ADDENDUM NO. 2 TO PROJECT NO. 43707

**ELEVATOR, ELECTRICAL & PLUMBING WORK
PROVIDE STAGE & DRESSER LIFT
GNARESP THE EGG
EMPIRE STATE PLAZA
ALBANY, NEW YORK**

October 31, 2013

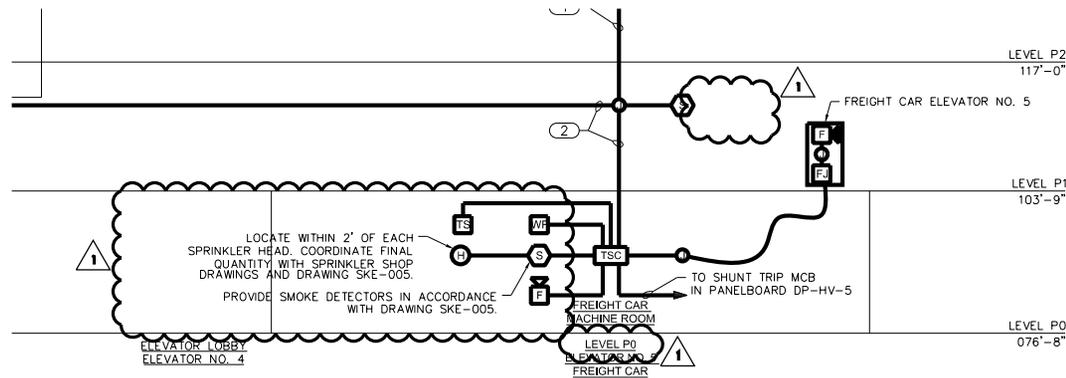
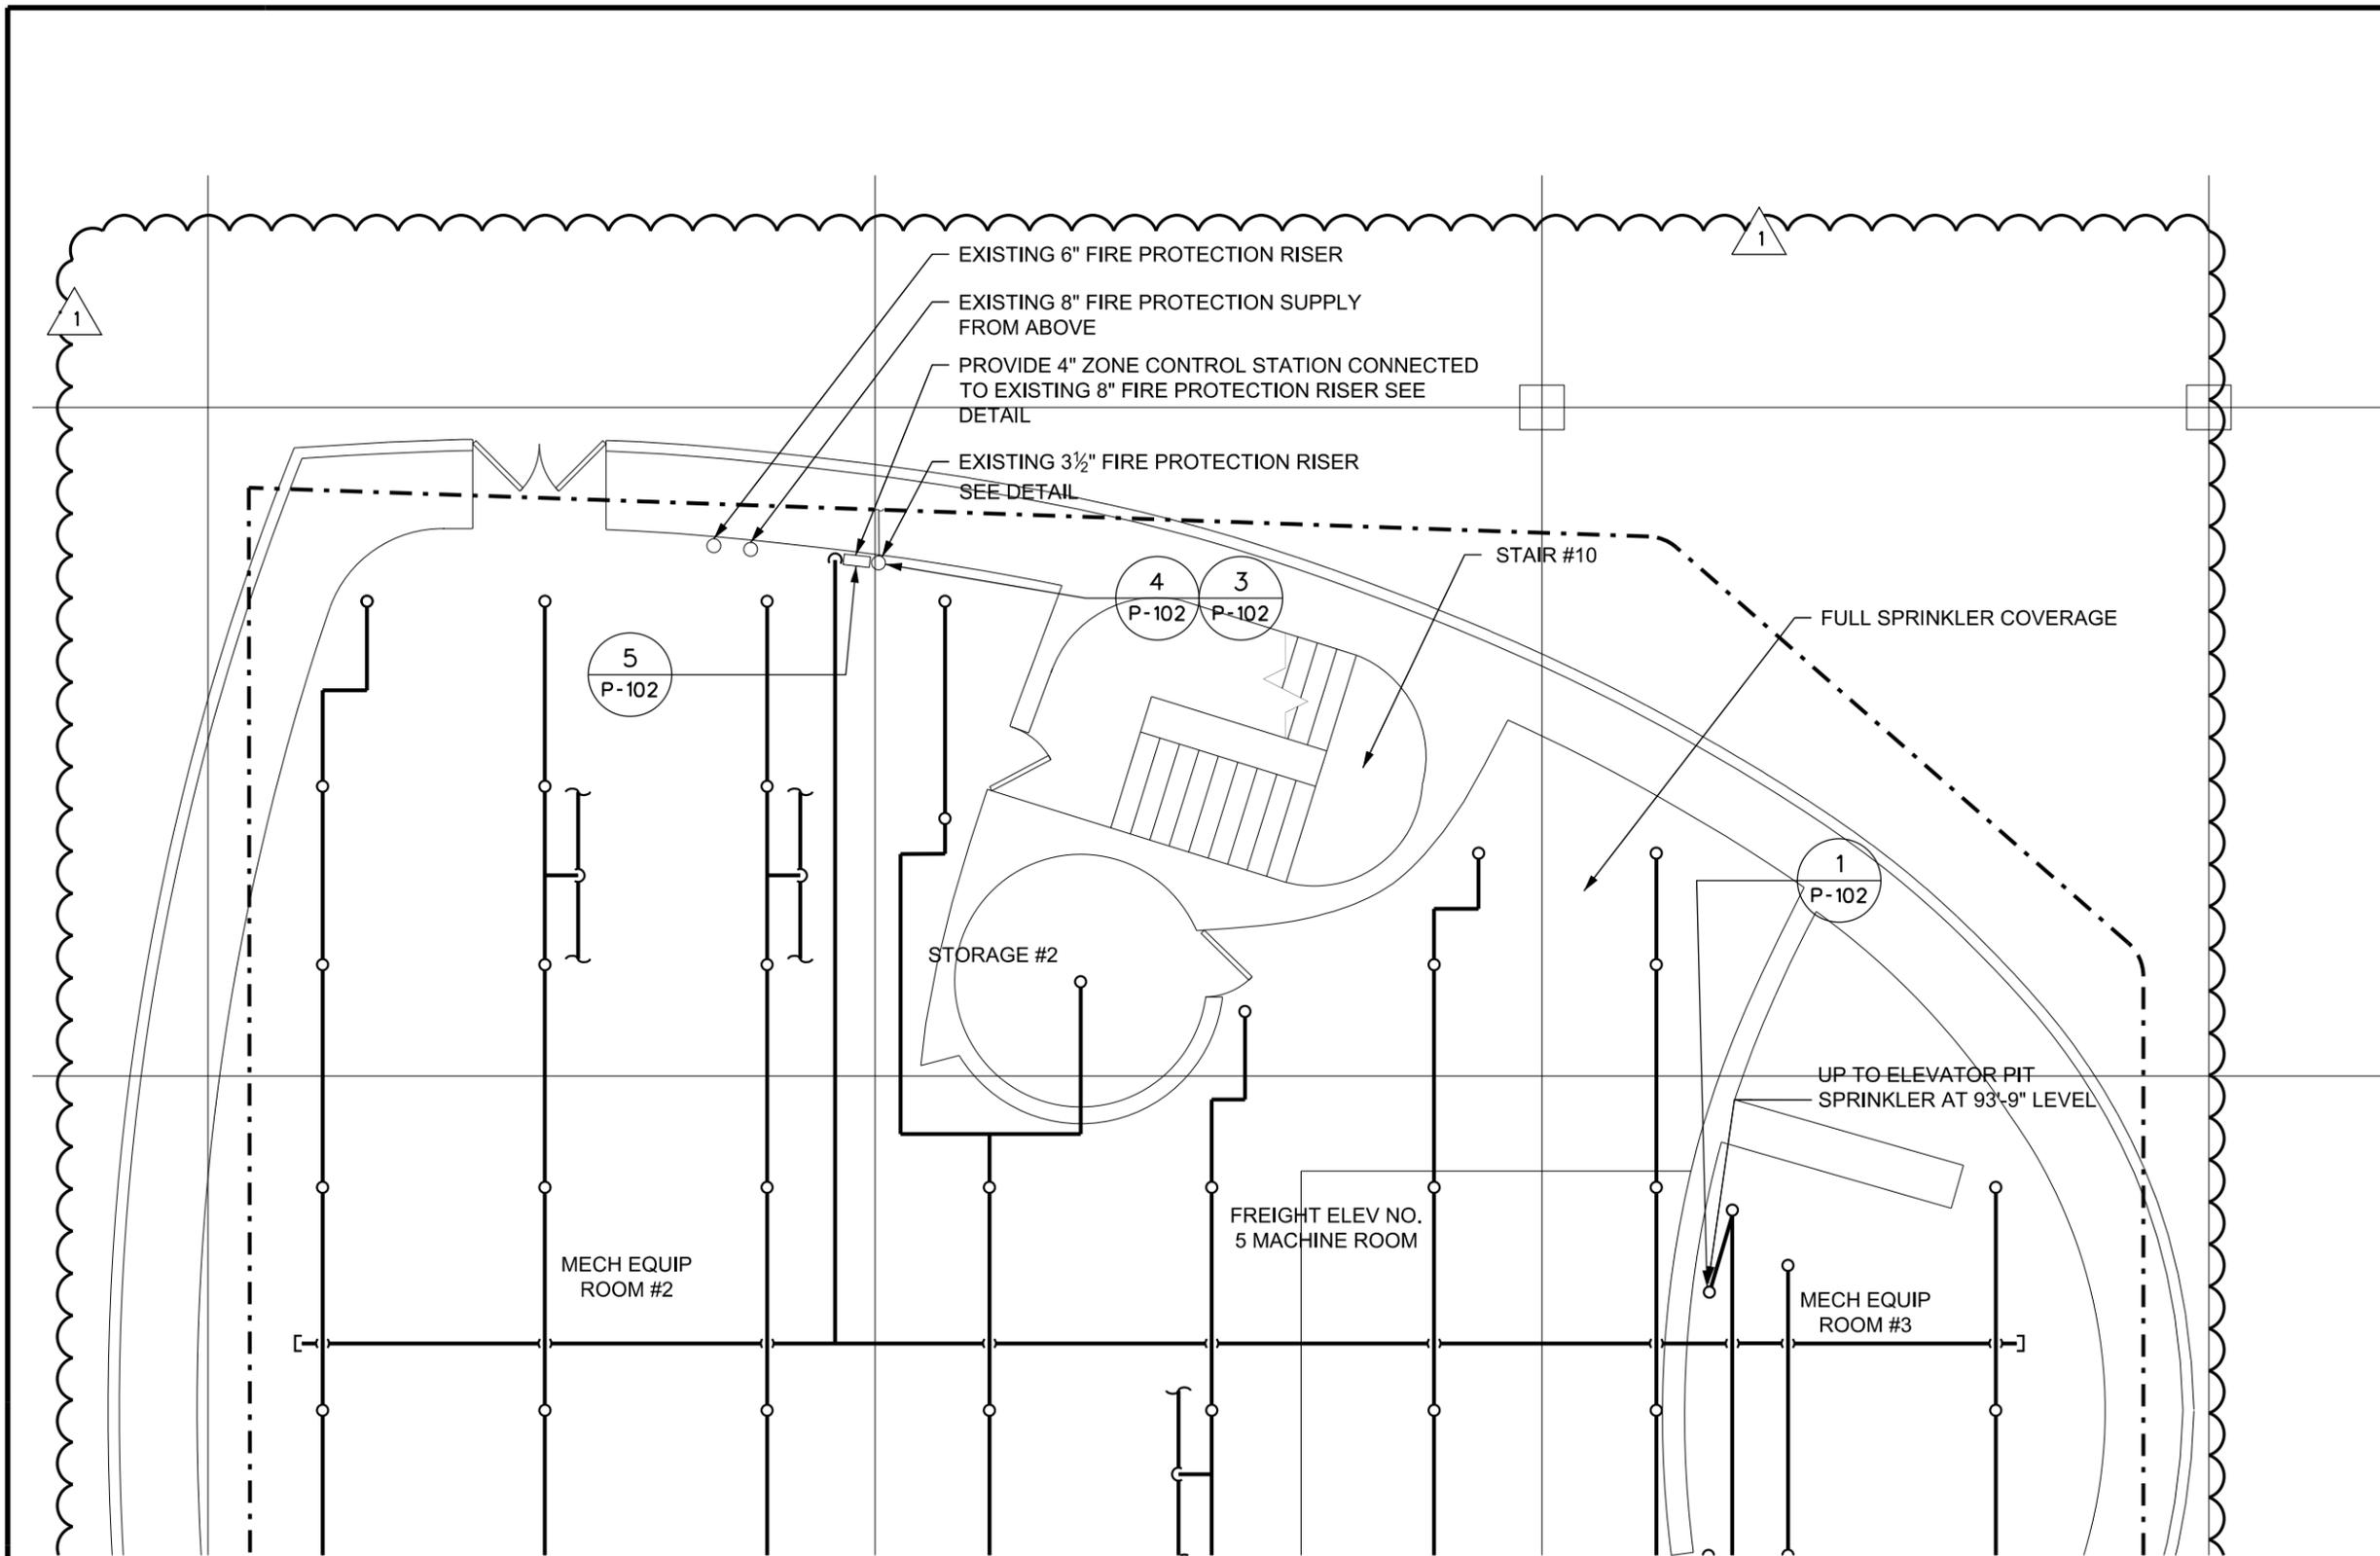
36. Drawing E-704:
 - a. Detail 1: Revise to reflect new fire alarm work. Refer to sketch SKE-007 (attached).

SKP-002

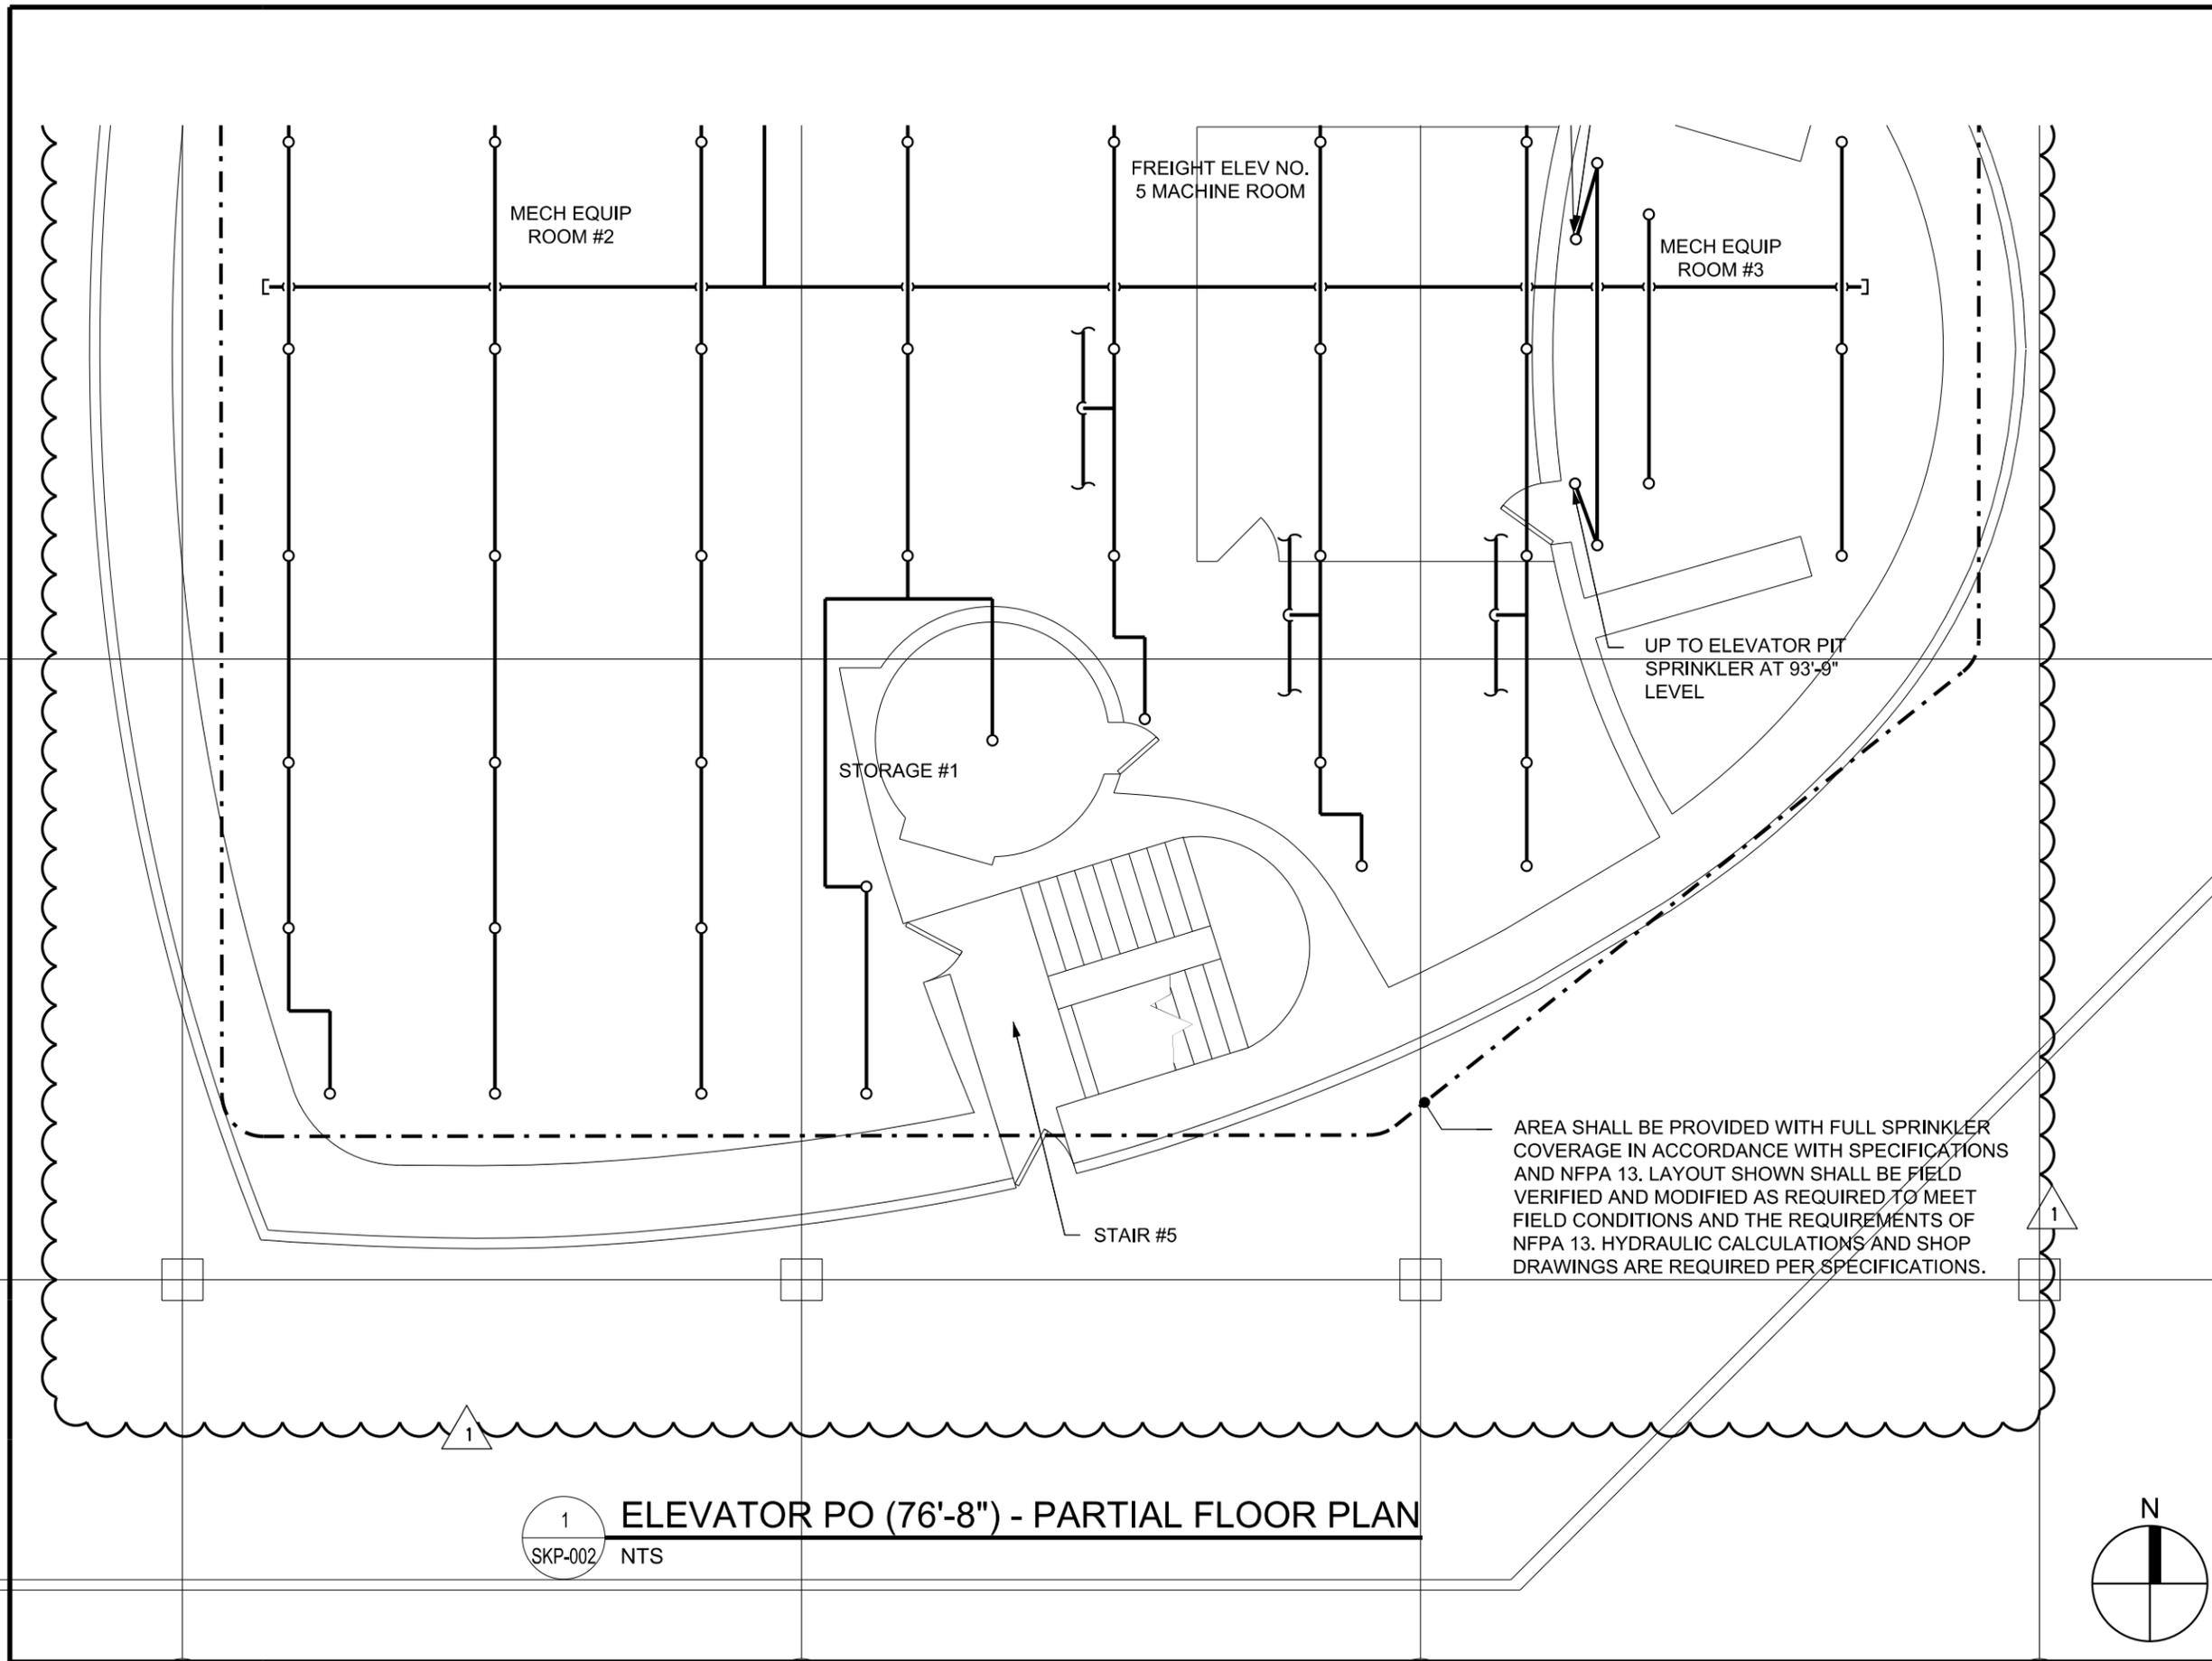
- a. Detail 2: Refer to sketches SKP-001 and SKP-002 for revisions (attached).
- b.
